Date: March 11, 2003

To: T10 Committee (SCSI)

From: George Penokie (IBM/Tivoli)

Subject: Section 7 Changes

Figure 16 — SSP (link layer for SSP phys) state machines (part 2-1 - frame ~~reception~~transmission)

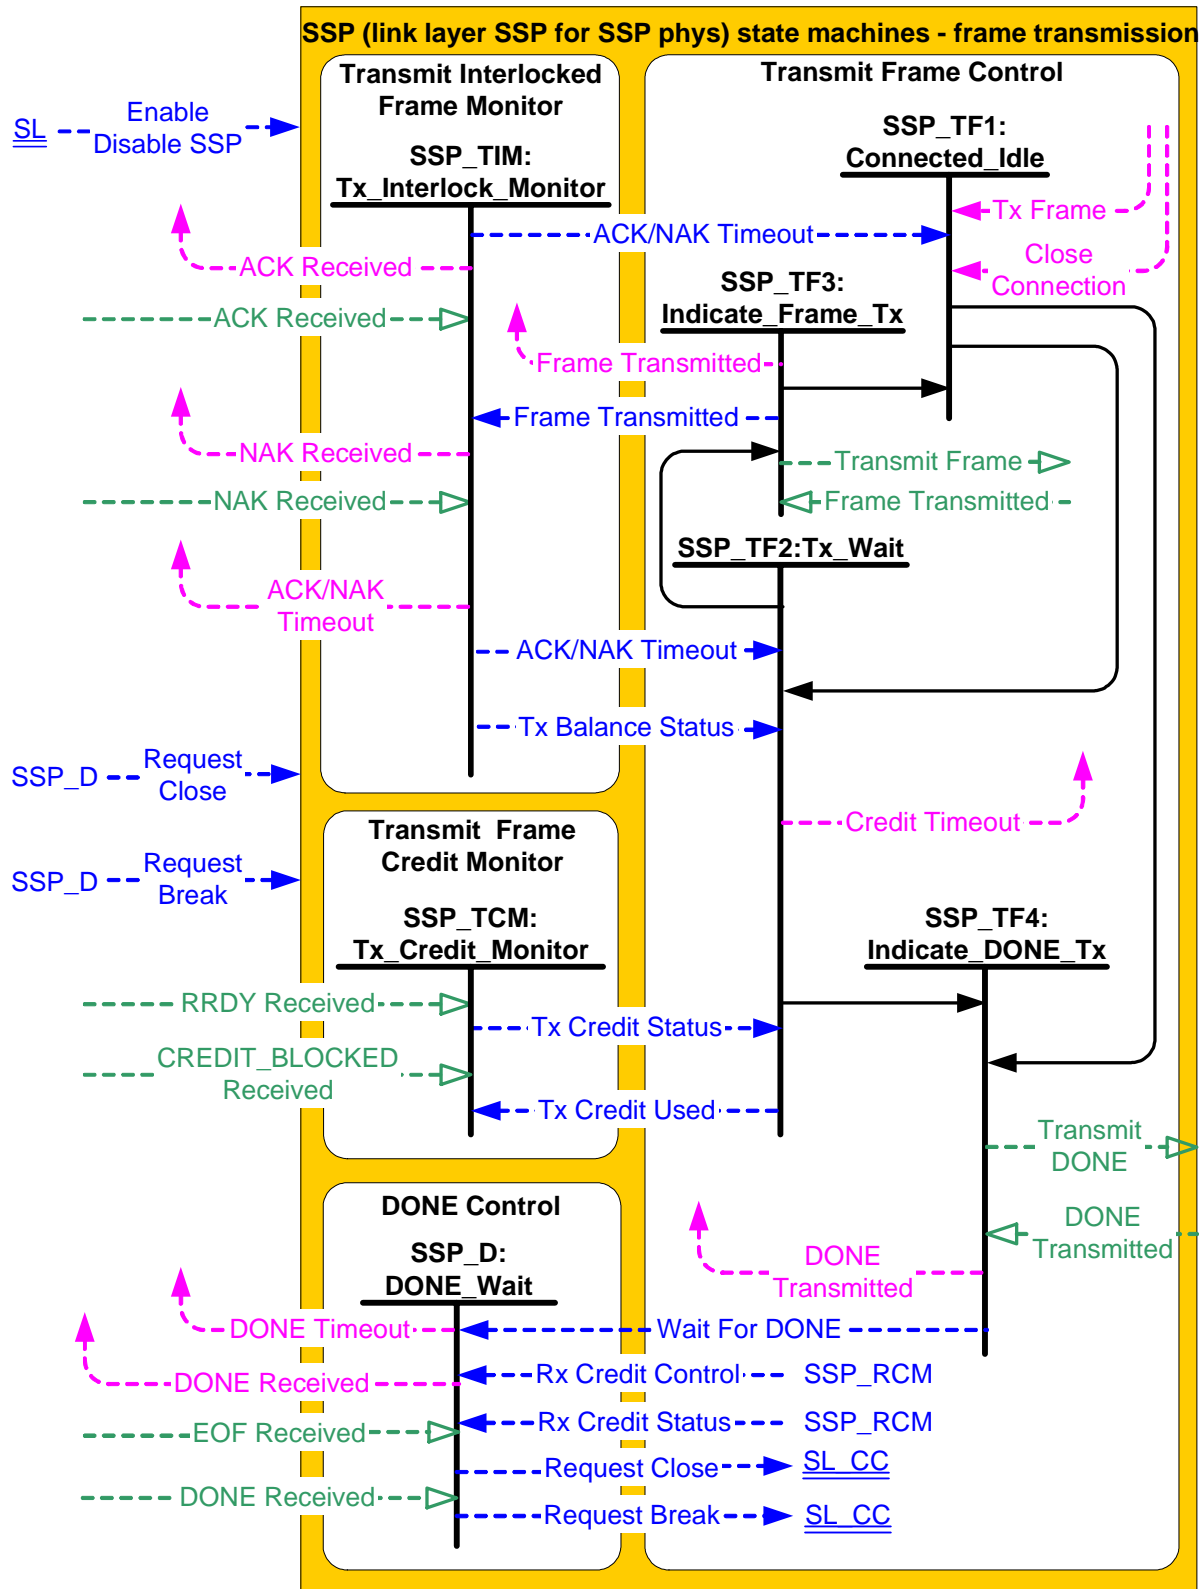
Figure 16 shows the SSP state machines and states related to frame ~~reception~~transmission.

Figure 17 — SSP (link layer for SSP phys) state machines (part 3-2 - ~~primitive transmission~~ frame reception)

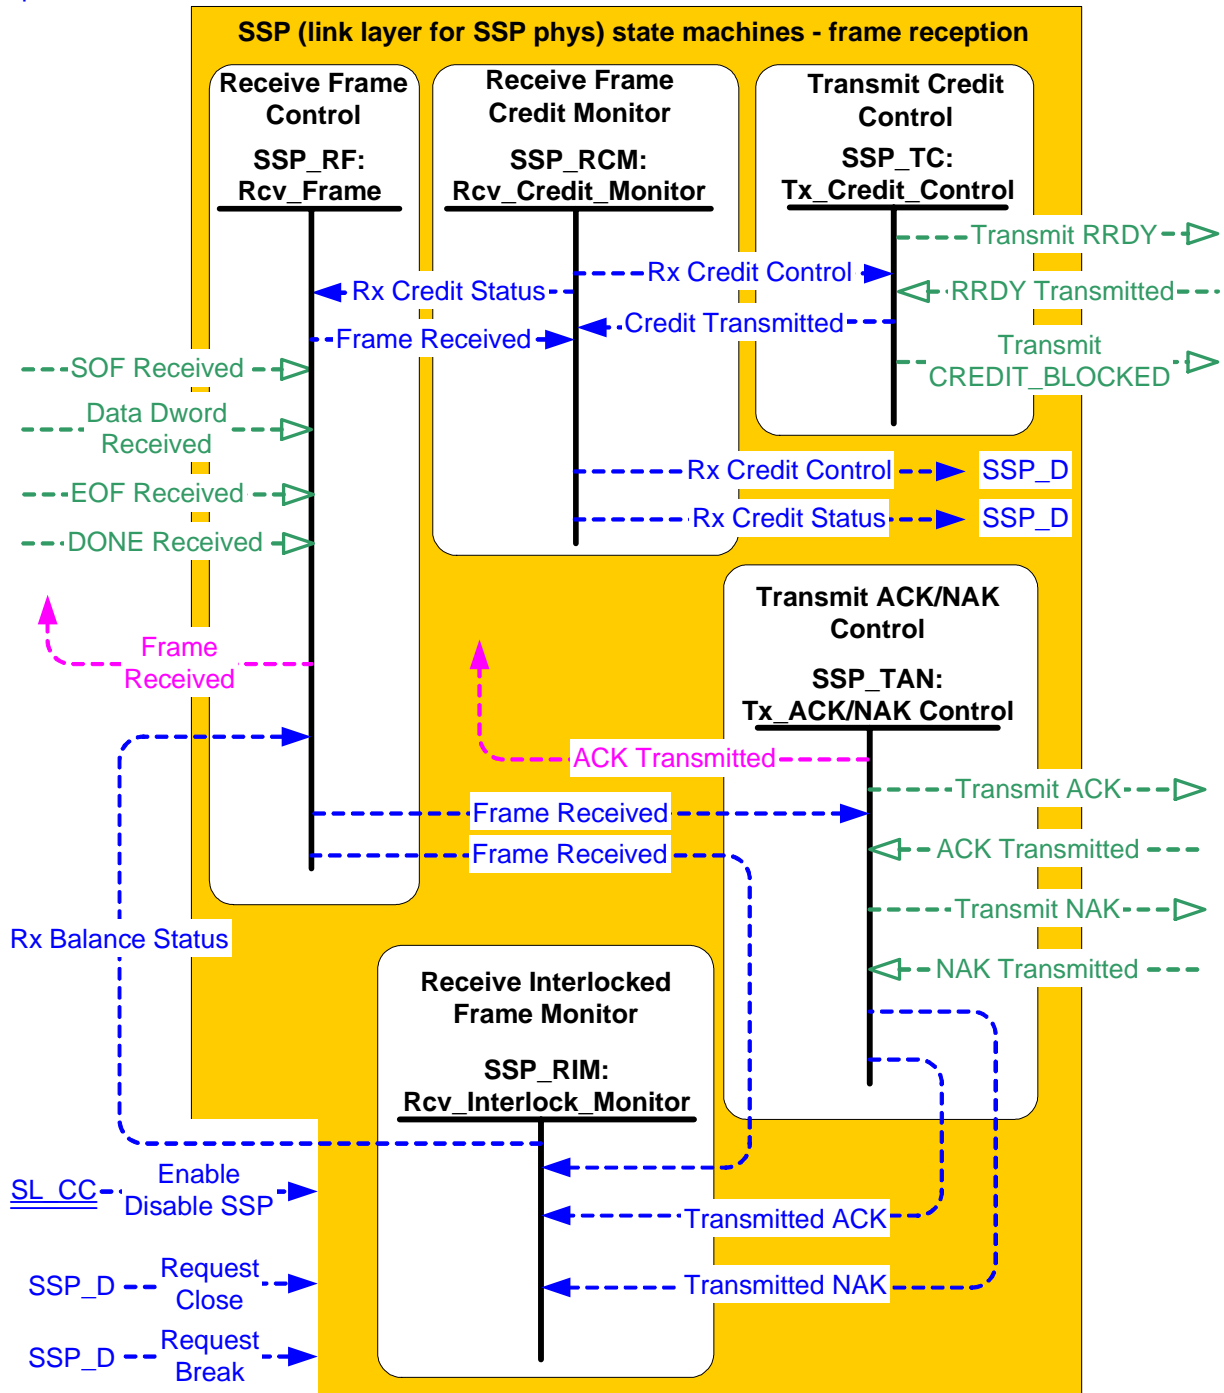
Figure 17 shows the SSP state machines and states related to ~~primitive transmission~~ frame reception.
